FACILITY AUXILIARY BUILDING
UNIVERSITY OF SOUTH CARLINA AIKEN
STATE PROJECT NO.: H29-9552/50003331-2
JCS PROJECT NO: 18103

ADDENDUM #02
June 11, 2019

DRAWN BY: JH
CHECKED BY:
COMM NO: 18103
DATE: APRIL 12, 2019
SHEET TITLE: FLOOR PLAN
SHEET NO: A301

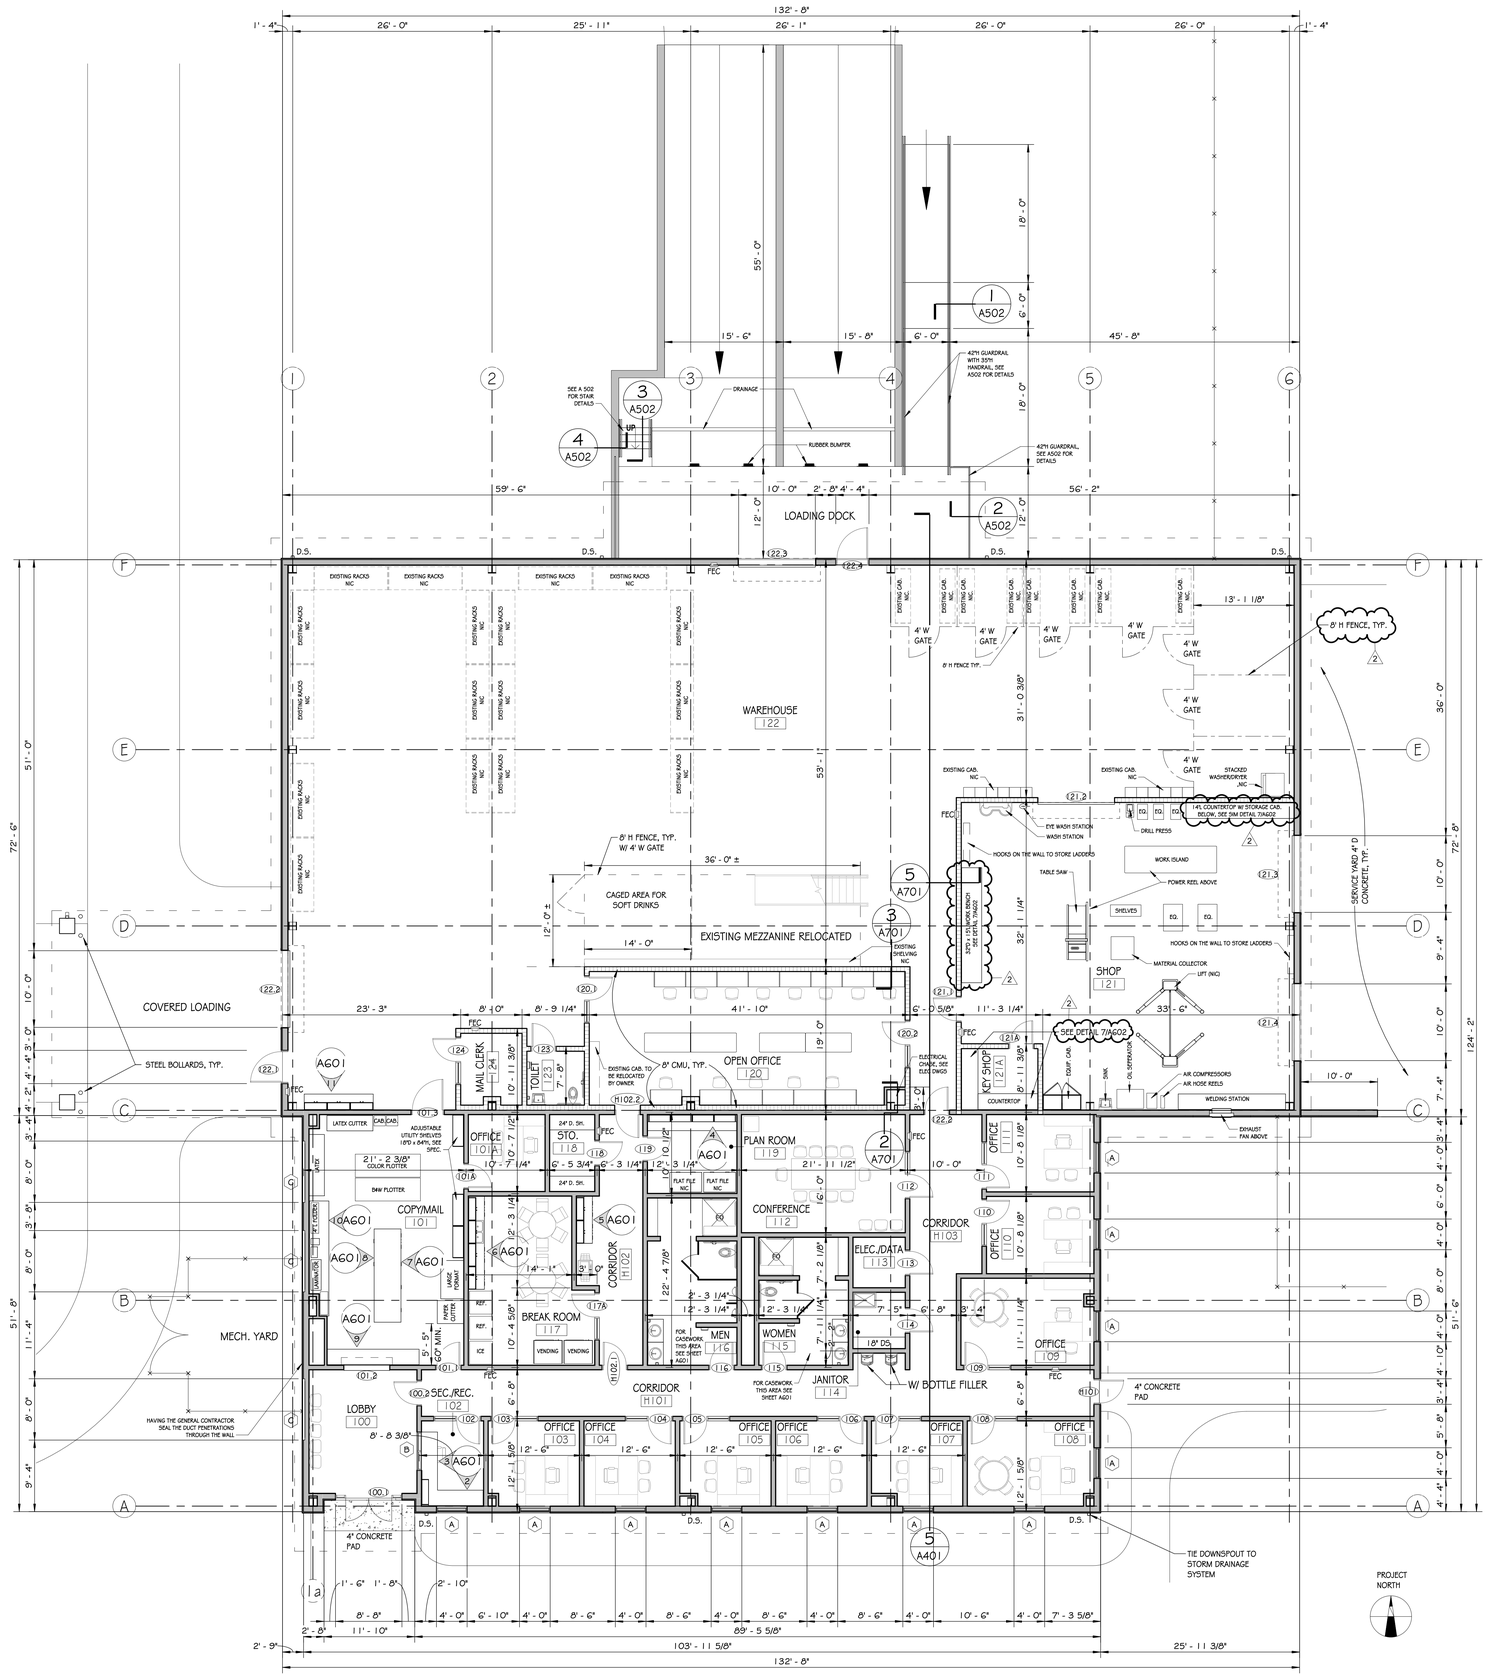
9. Q: Clarify the responsibility of relocating the existing metal framed mezzanine.
   A: The Owner will relocate the existing metal framed mezzanine
10. Q: What equipment in Shop Area 121 is provided by GC?
    A: Eyewash station, wash basin, and work bench countertops as noted on revised Sheet #A301

DRAWN BY: Author
CHECKED BY: Checker
COMM NO: 18103
DATE: FEB 2019
SHEET TITLE: FOUNDATION COVERED STORAGE BUILDING
SHEET NO: S104

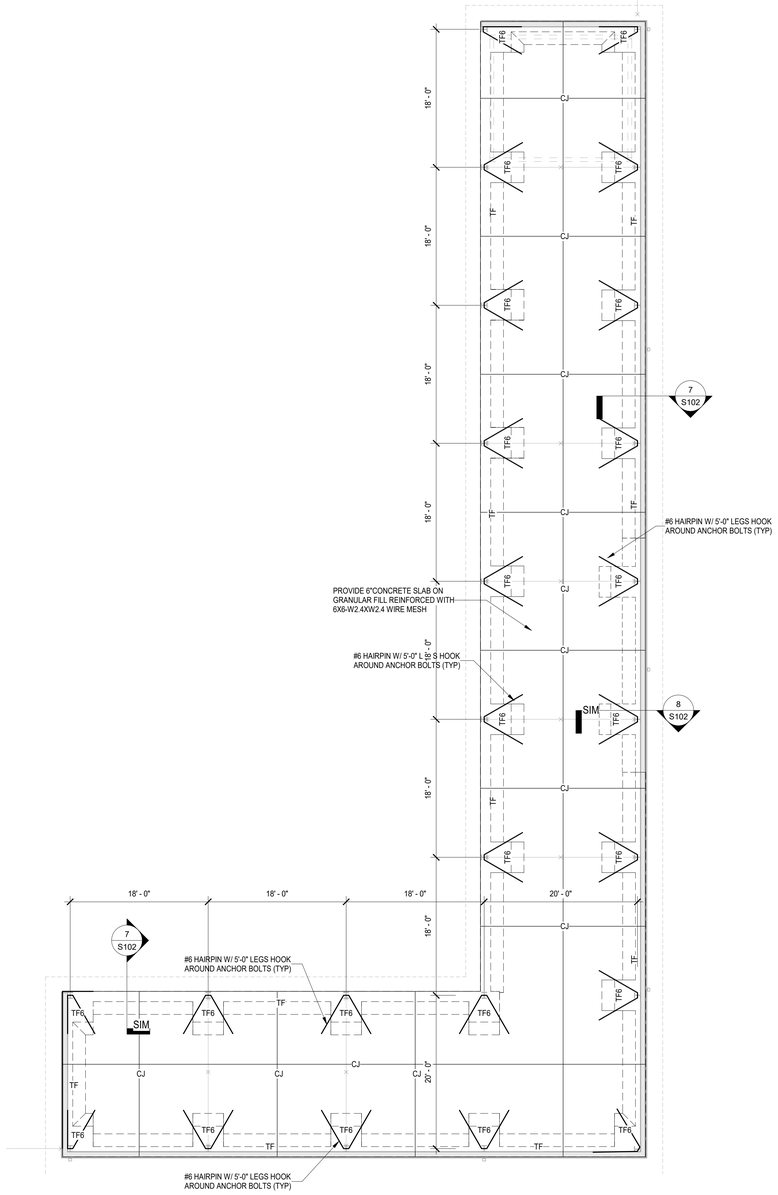
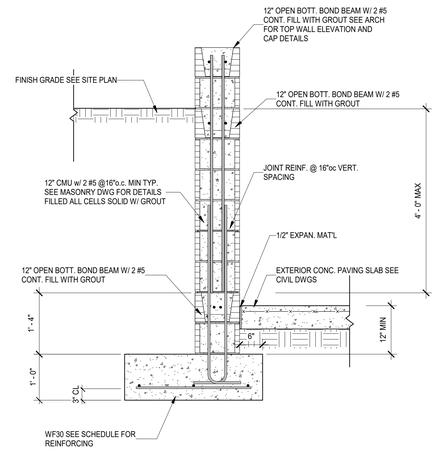
10. **SHEET #S104 Covered Storage Foundation Plan: Add** this sheet to the bid set.
11. **SHEET #M201 Details, Notes, Schedules and Legend:** Reference VAV Package Control Diagram. Control Contractor to coordinate actual electrical heater stages with equipment provided.
